# YANKEE ATOMIC ELECTRIC COMPANY

2.C.2.1  
FYR 85-132

Subject: TMI Item II.D.1 Safety and Relief Valves

QUESTIONS RELATED TO THE SELECTION OF TRANSIENTS AND VALVE  
INLET AND DOWNSTREAM CONDITIONS

FIGURE 1

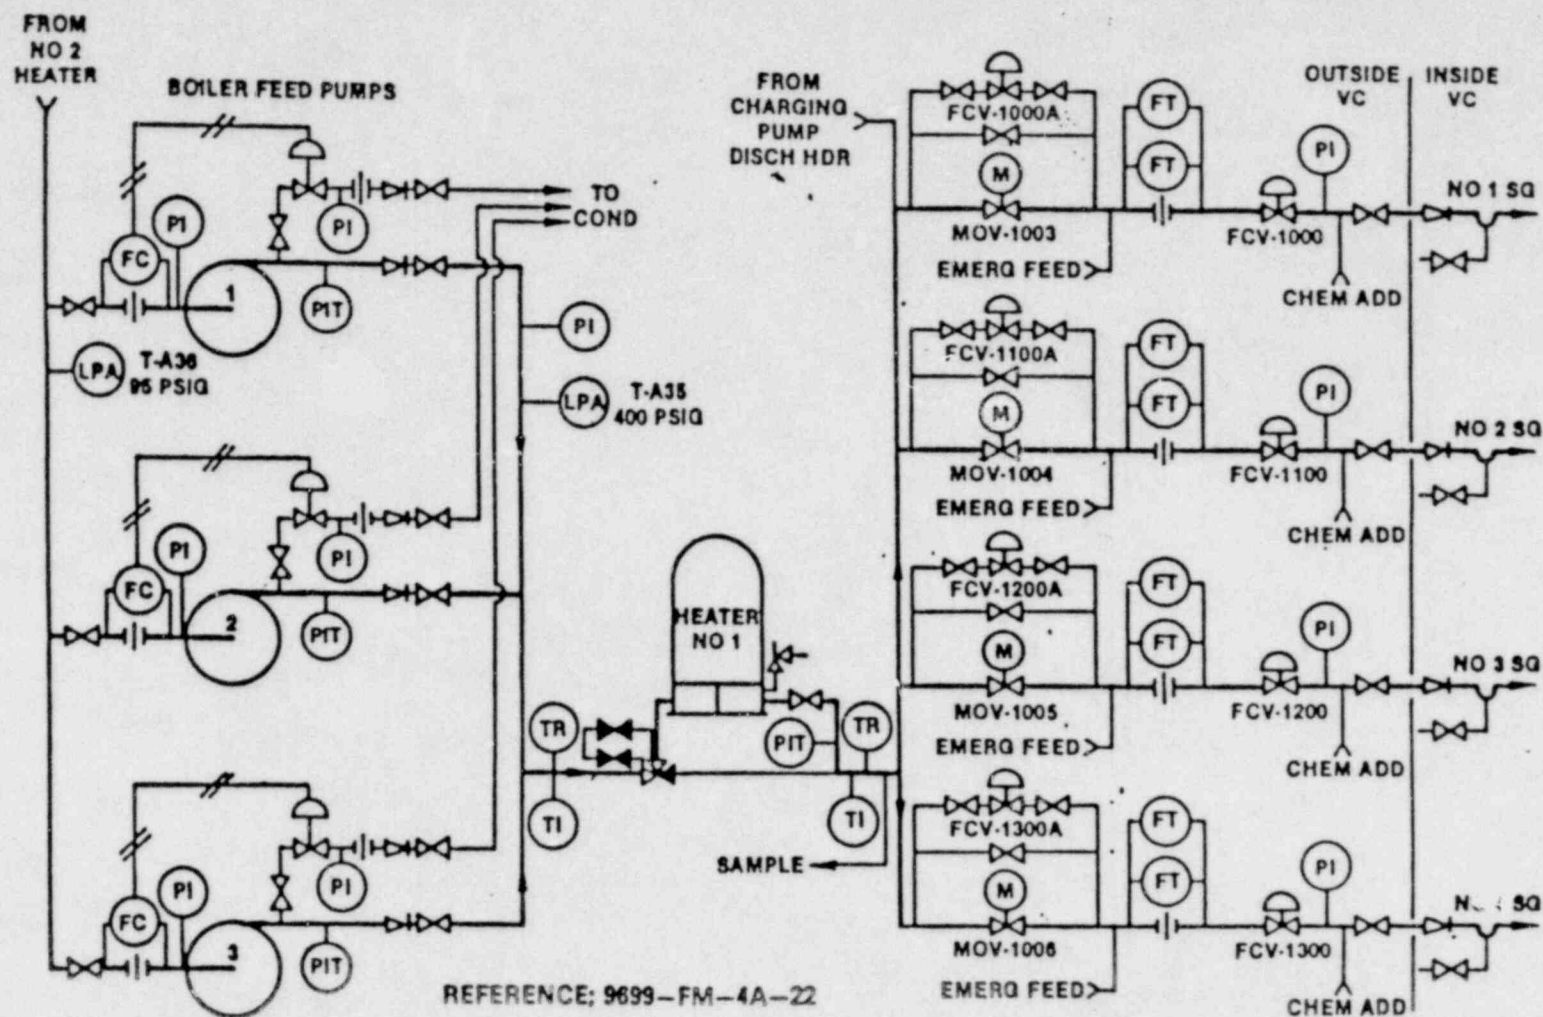
3. The Yankee submittal did not discuss the feedline break event. NUREG-0737, II.D.1, requires that the transients of Regulatory Guide 1.70, Revision 2, be considered. The feedline break is included in these transients. Discuss the feedline break event providing peak pressure, pressurization rate, temperature, discharge flow rate and expected fluid. Demonstrate safety and PORV functionability for this event, and consideration of this event in the discharge piping analysis.

The licensing basis for the Yankee plant does not specifically treat a feedwater line break transient. As discussed in the February 1, 1982 NRC submittal concerning SEP topic XV-6, "Feedwater System Pipe Breaks INside and Outside Containment (PWR)", the safety objectives for this transient are contained within the safety objectives of the Main Steam Line break and complete loss of feedwater events. The effects of these transients encompass the feedwater line break event.

Figure 1 shows the schematic diagram for the feedwater system at the Yankee plant. A reverse-flow check valve exists in each of the four normal feedwater lines that provide feedwater to the steam generators. Each feedline also contains a motor-operated gate valve to provide for feedwater isolation, and a flow control valve.

There are two possible cases for the feedwater line break event, depending on the break location. If the break occurs upstream of the reverse-flow check valve in any feedline, the transient will be essentially identical to a complete loss of feedwater event. If the break occurs downstream of the reverse-flow check valve, a single steam generator will blow down, discharging its inventory to the containment atmosphere. This will initially cool and depressurize the Main Coolant System, similar to a Main Steam Line break event. This cooldown will be followed by a primary system heatup on decay heat, until the operators terminate the transient by opening the Emergency Atmospheric Steam Dump valves on the intact steam generators.

For both cases of a feedline break event, the peak pressure, pressurization rate, Main Coolant temperature, discharge flow rate, and fluid conditions at the valves are bounded by the complete loss of load analysis. Since a feedwater line break upstream of the reverse-flow check valves is essentially identical to a complete loss of feedwater event, the requested parameter values are bounded by the loss of feedwater analysis which is, in turn, bounded by the complete loss of load analysis.

For a feedwater line break downstream of the reverse-flow check valve, the heatup portion of the transient is less severe than for a complete loss of load event. Therefore, the peak pressure, pressurization rate, primary temperature, and discharge flow rate are bounded by the loss of load analysis. This assumes that the pressurizer safety and relief valves are relieving dry steam. Therefore, it remains only to show that the fluid conditions at the valves will be steam and not water for a feedwater line break downstream of the reverse-flow check valve.

YANKEE ROWE PSARV PIPING  
 STEHAM COMPUTER MODEL

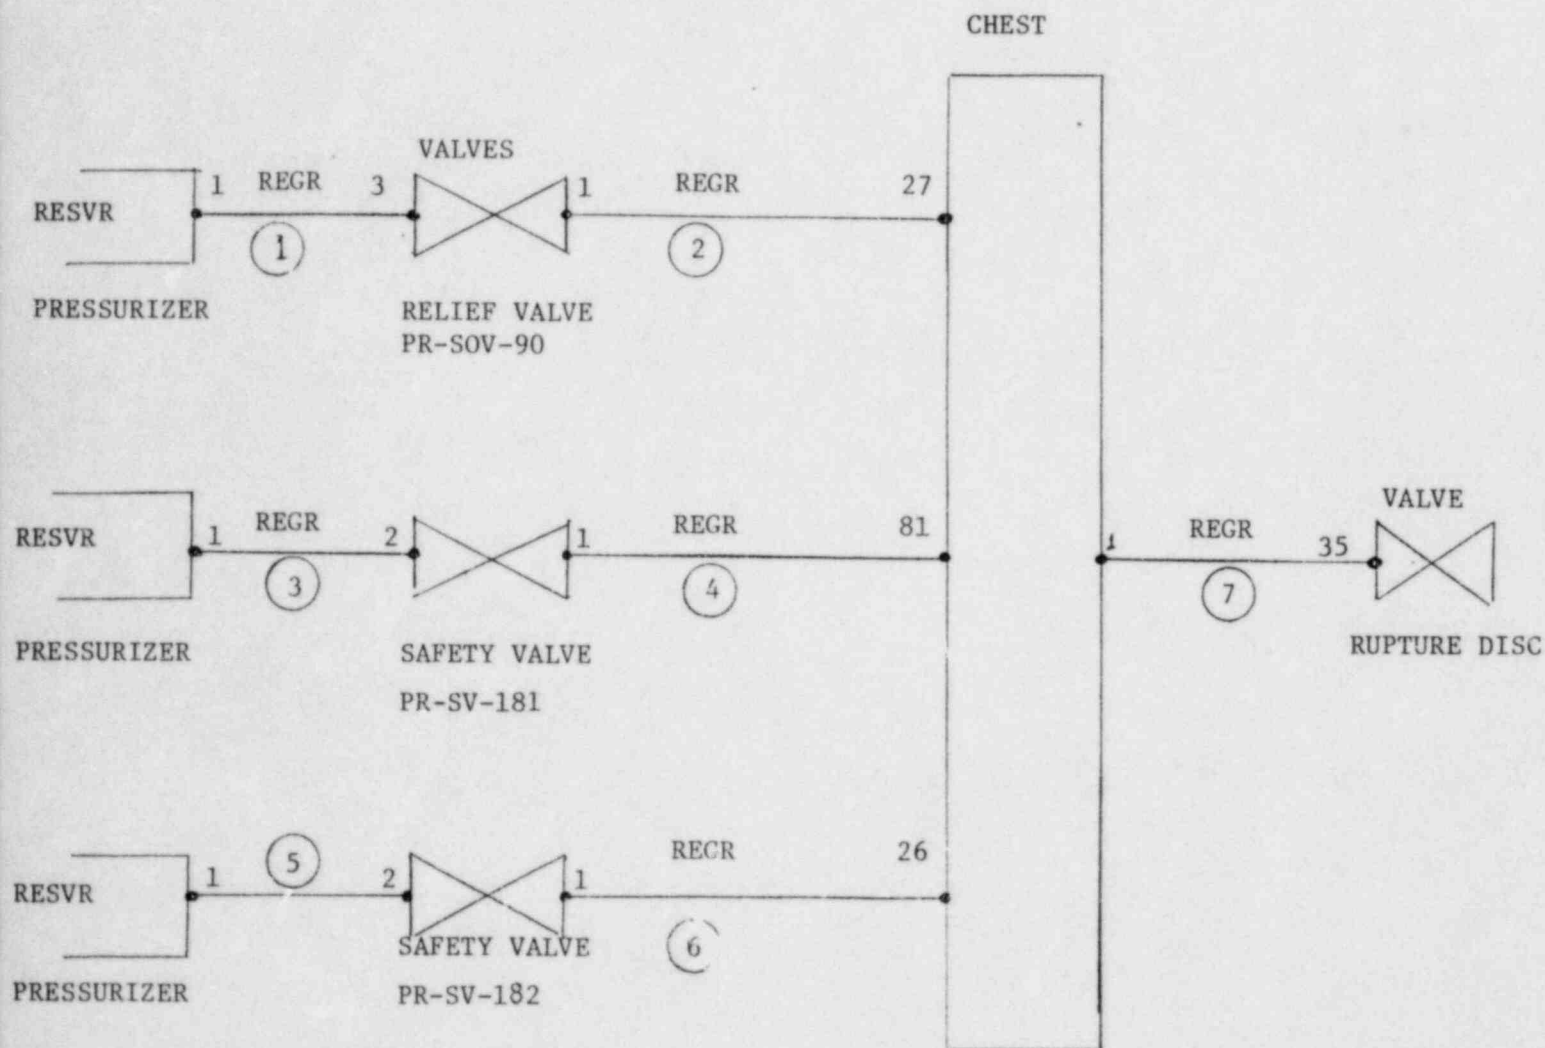
- (e) A discussion of the sequence of opening of the safety valves that was used to produce worst case loading conditions.
  - (f) A sketch of the thermal hydraulic model showing the size and number of fluid control volumes.

The STEHAM Program was utilized to develop force time histories for discharge piping due to the steam discharge of each safety/relief valve. Three fluid transient cases, i.e., relief valve opening, safety valve opening with relief valves closed, and safety valve opening with relief valve already open, were analyzed. The two safety valves were conservatively considered to open simultaneously.

- (d) The safety and relief valves are treated as a convergent-divergent nozzle in STEHAM analysis with choked or non-choked flow detection. The relief valve is treated as orifice in WATAIR analysis. The flow rate and valve resistance (discharge or loss coefficients) are reported in Table 1. ASME code derating was considered in the analysis.
- (e) The two spring-loaded code safety valves were assumed to have the same set pressure of 2485 psig, such that simultaneous opening is considered for the thermal hydraulic analysis. The actual setpoints are 2485 psig and 2560 psig respectively.
- (f) Thermal hydraulic models for STEHAM and WATAIR are shown in Figures 1 and 2. Control volume modeling technique was not used in the analysis. The branch, node, segment numbers along with forcing function direction are shown on these figures. Piping dimensions are delineated in Table 2.

FIGURE 18

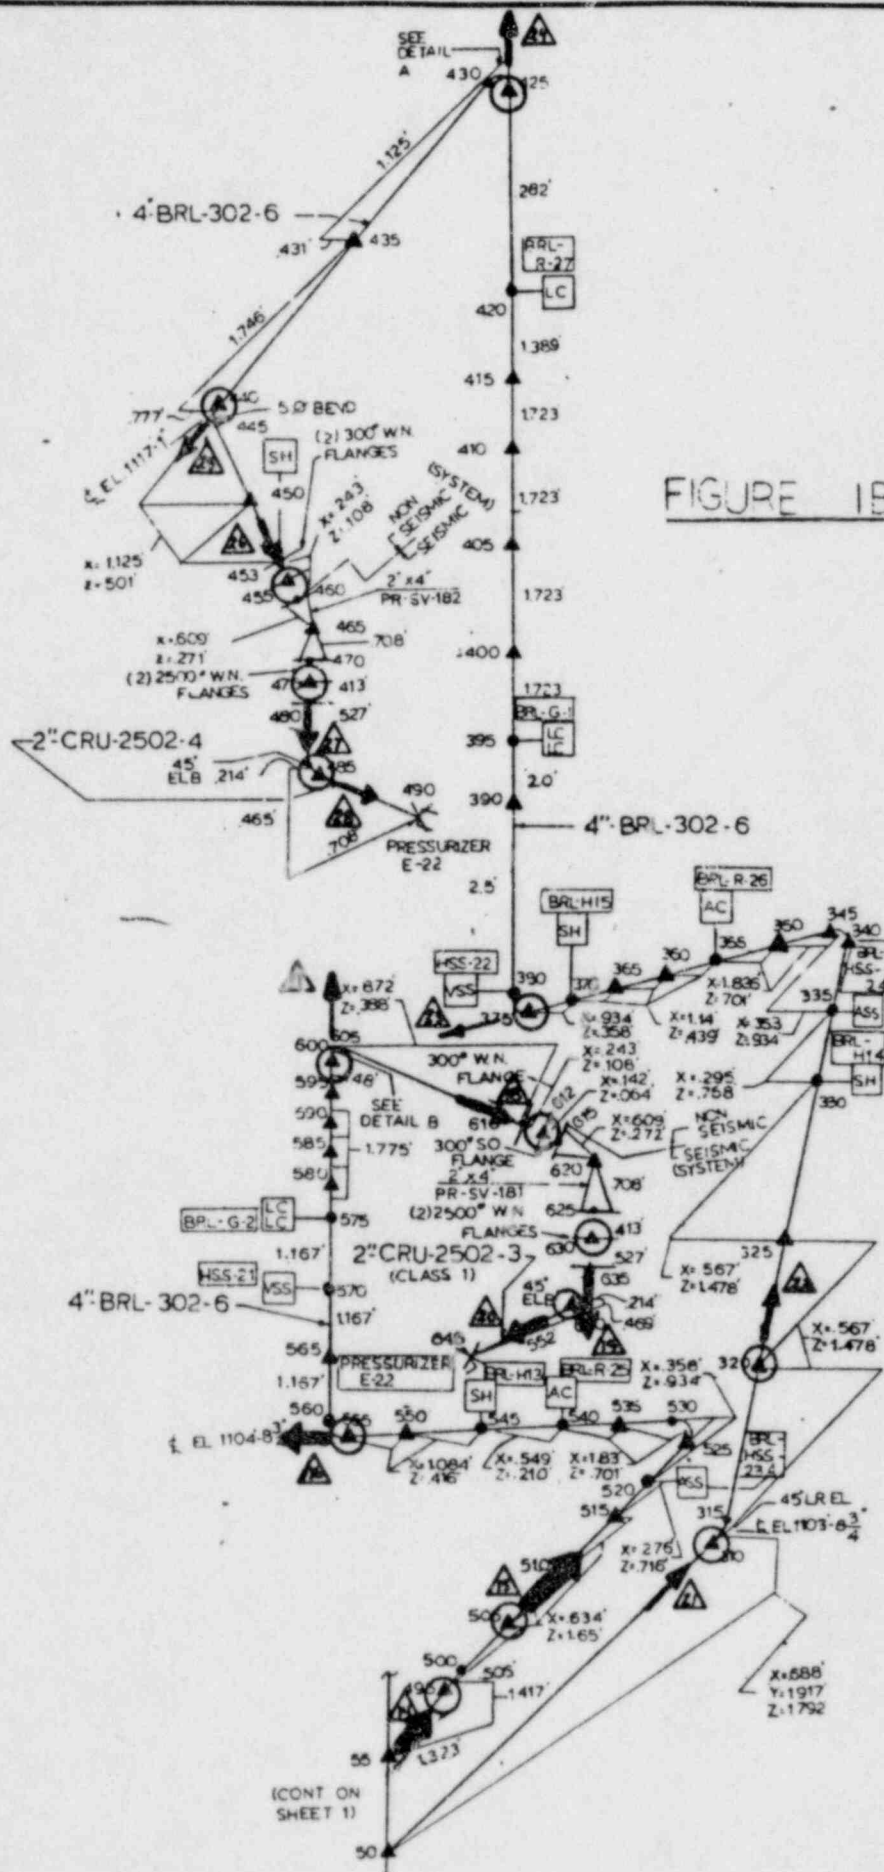
- (g) A sketch of the structural model showing lumped mass locations, pipe sizes, and application points of fluid forces.

- (f) Table 1 shows the maximum stress level in the piping system. The results indicate that the maximum stress level in the piping system meet the code allowable limits for all loading conditions.
- (g) Figure 1 shows the mathematical model utilized for the structural analysis of the piping system. The mathematical model shows the lumped mass point locations (identified by  $\Delta$ ) and pipe sizes. The fluid forces are applied at all elbows but not indicated on the figure.
